FACILITY PERMIT

12-139219-000-00-FA

Project Description: F16/ BOILER FUEL SYSTEM UPGRADE, NEW 33' X 13' PAD WITH NEW 10,000 GAL ABOVE GROUND FUEL TANK, VEHICLE BARRIERS, AND RELATED FUEL PIPING INTO THE HOSPITAL. SEE BUILDING PERMIT FOR NEW FOOTING, SLAB, AND SEISMIC ANCHORAGE FOR FUEL OIL TANK

FPP Structural Checksheet Response

1/S7 TYP. BOLLARD.

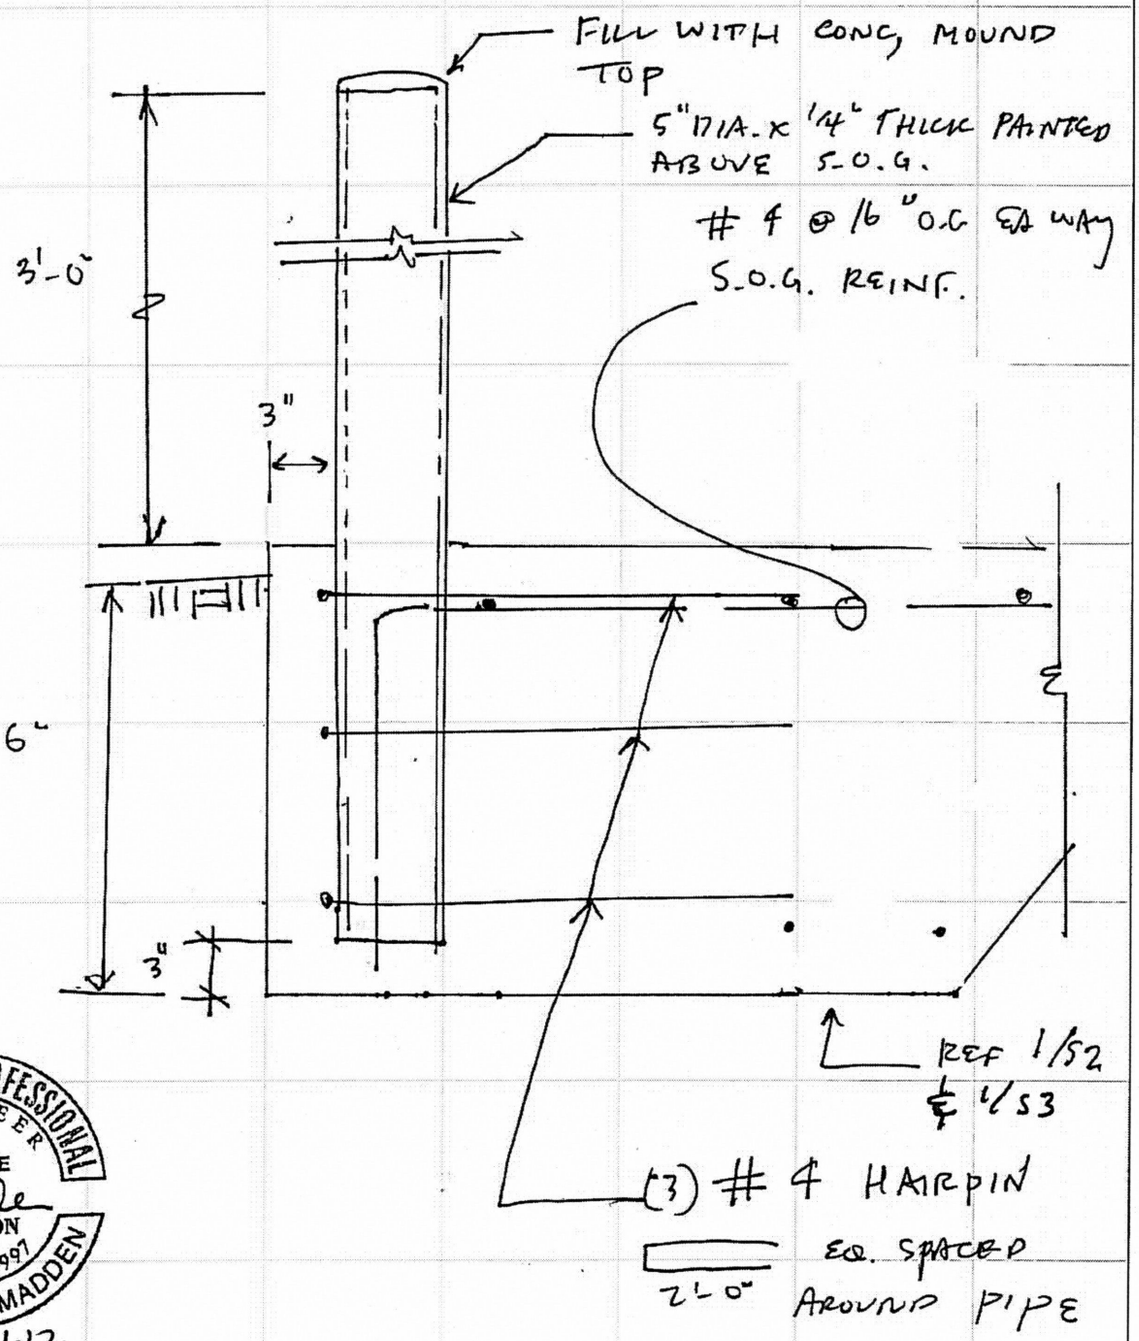
#	Description of changes, revisions, additions, etc.	Checksheet and item #
1	BOLLARDS ADDED TO PROVIDE VEHICLE PROTECTION. DRAWINGS AND CALC'S ATTACHED.	1
2	MECHANICAL & STRUCTURAL VALUATIONS SENT VIA EMAIL TO DAVID ROCK ON 5/11/2012.	2

BOLLARD:

$M = 9$ kft. (ASD)

$M_{ULT} = 9(1.6)$
$= 14.4$ kft.

$T_{ULT} = 14.4$ kip.

#4 HAIRPIN: $\phi T_N = .2(60)(.85) = 10.2$

$\phi T_N > 7.2$ kip
10.2

USE (3) #4 HAIRPINS.

CHECK PIPE: $S_{xx} = 5.5$.
5" DIA x 1/4"

$f = \frac{9(12)}{5.5} = 19.6$ ksi.

DOESN'T INCLUDE CONCRETE FILLED COMPONENT, O.K.

2 PLAN @ FUEL TANK
1/8" = 1'-0"

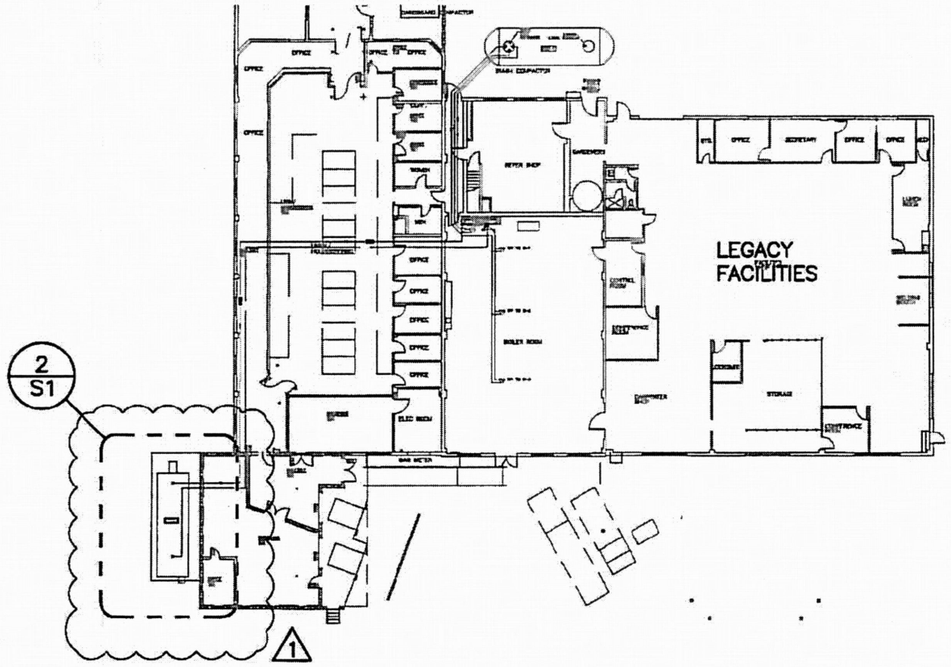
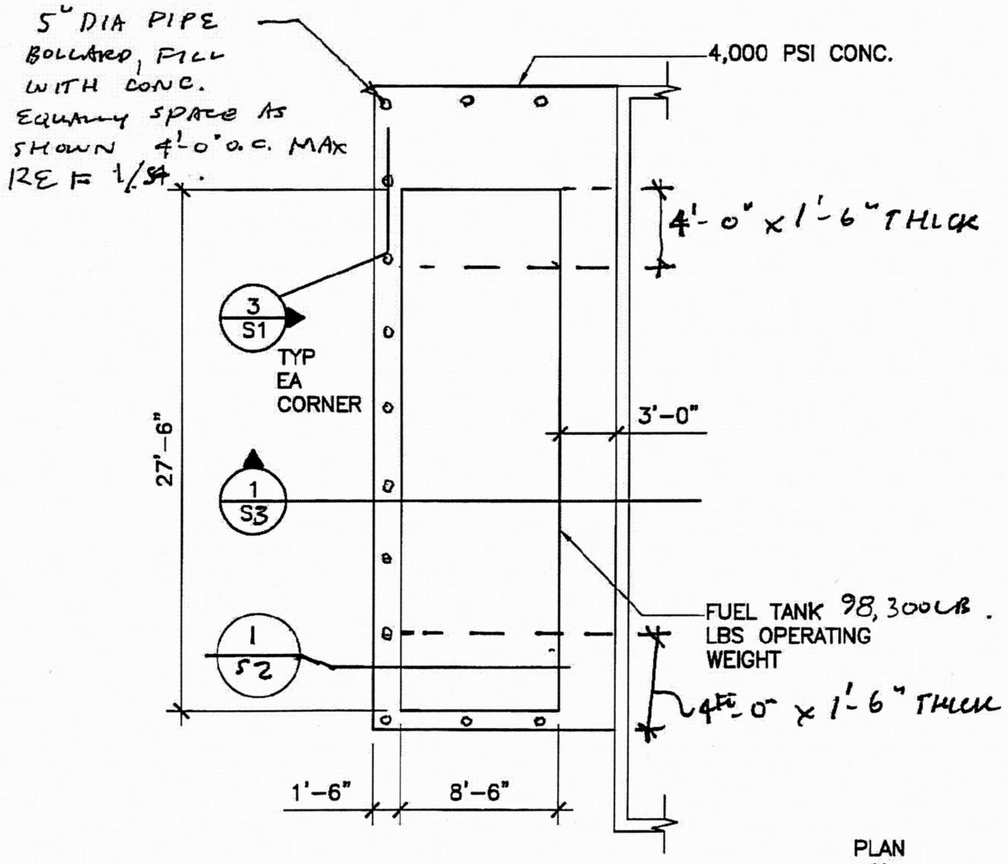
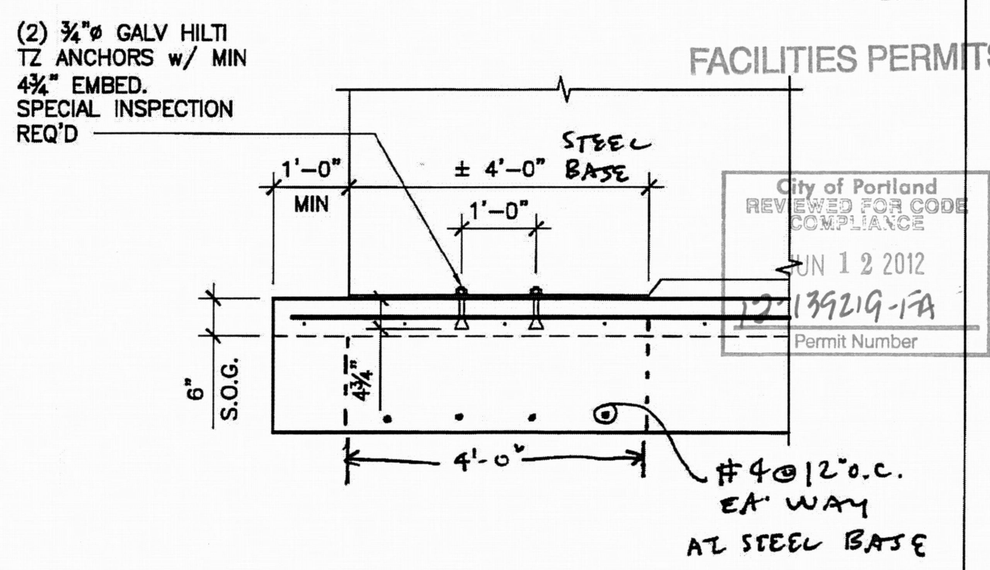
Attached please find revised calculations and drawings for the weight of the fuel in the fuel tank as noted in the plan review response for permit #12-139219-000-00-FA, and for bollards as required by the site review plan.

1 5.18.2012

1 SECTION – AT STEEL BASE

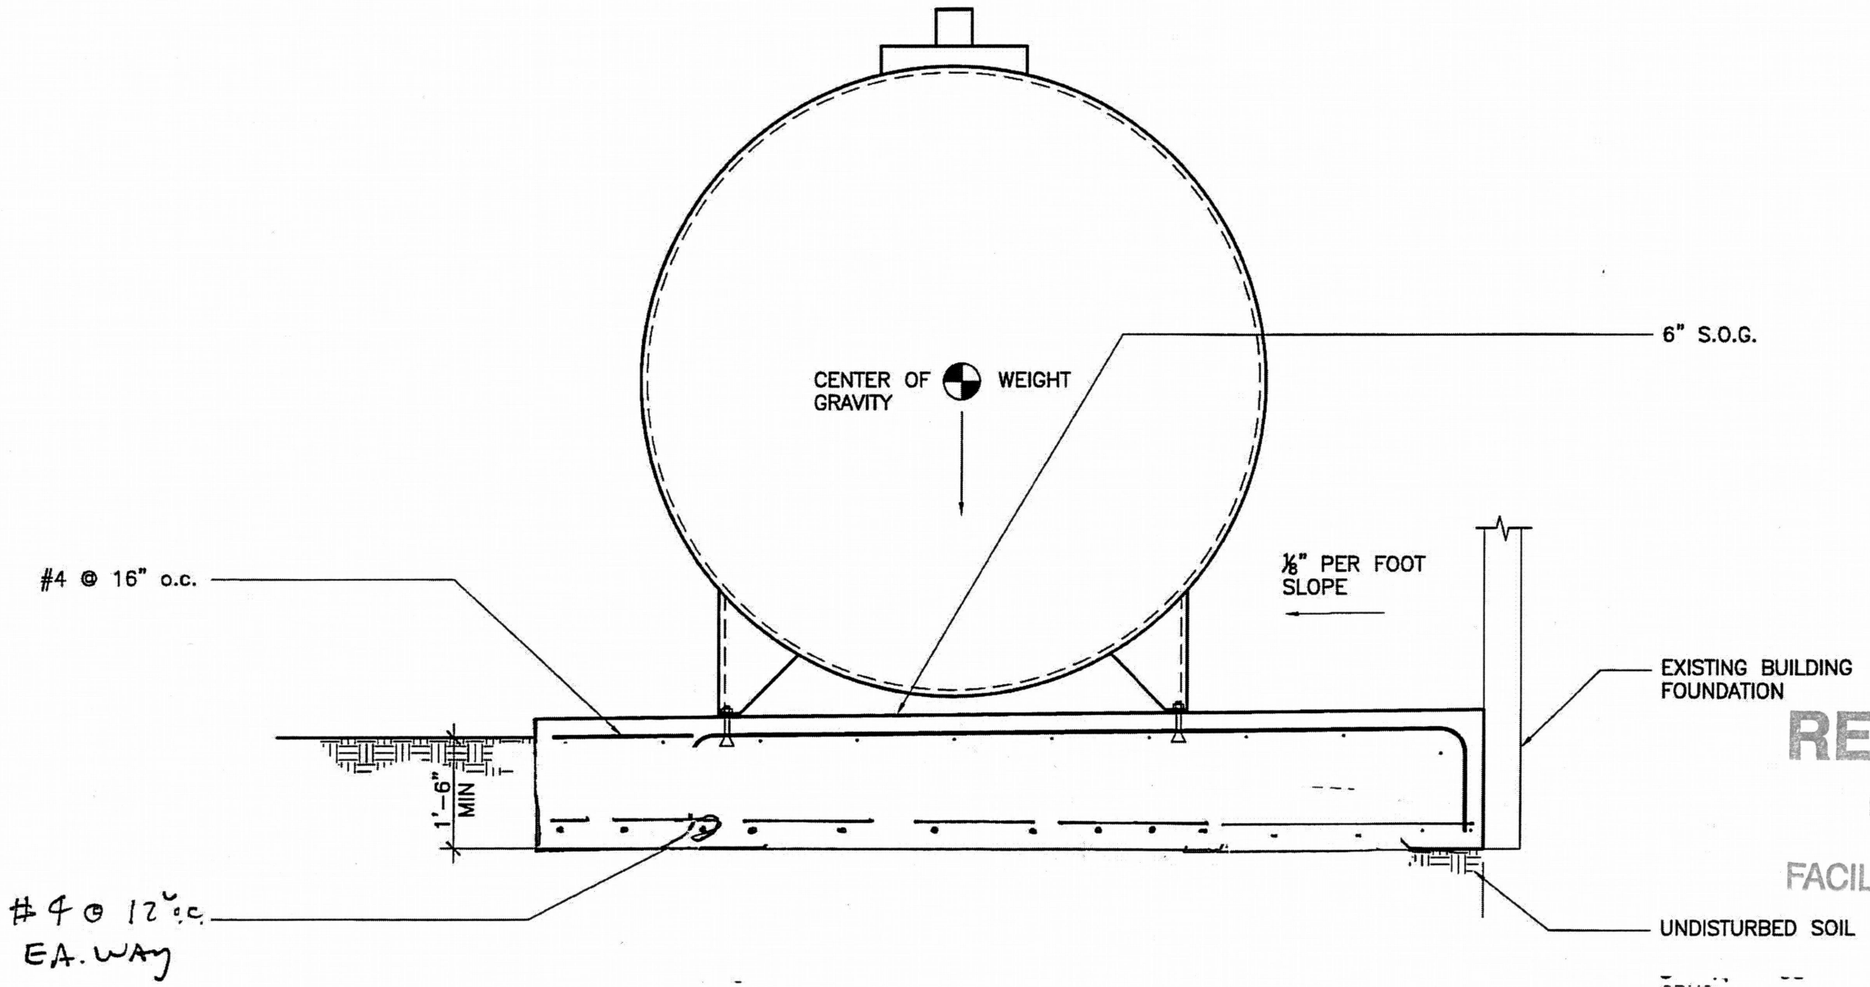
#	Description of changes, revisions, additions, etc.	Checksheet and item #
1	SPECIAL INSPECTION SHEET COMPLETED AND ATTACHED.	1
2	TANK WEIGHT CALCULATIONS AND DESIGN REVISED TO INCLUDE WEIGHT OF FUEL.	2

WT @ FOOTING:

ASSUME: 1500 psf

PER CORNER = 98.25 / 4 = 24 kip.

$A_{REQ'D} = \frac{24\ k}{1.5} = 16\ FT^2.$

AT 4'-0" LONG BASE

WREQD = 4 FT. ← USE UNIFORM THICKNESS AT STEEL BASE ACROSS FOOTING WIDTH.
